SERVICE MEMO

Dispenser(s): W100
Title: Water in Waste bucket / Release hose brewer 1B2C

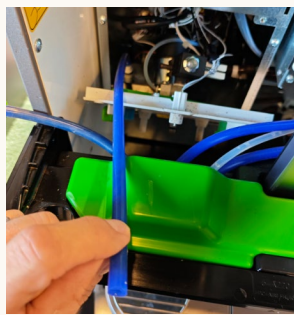
In the first production machines we see that the hose is too short, this results in release water after every coffee drink in the waste bucket.

Too short:

Correct:

Loop in machine:

Check at installation the length of the hose, it should be 40 cm and has to be in a loop.
(55009712 SILICONE HOSE 5X9 -BLUE-)

In production this will also be adjusted, first serial number with correct hose 44520478.
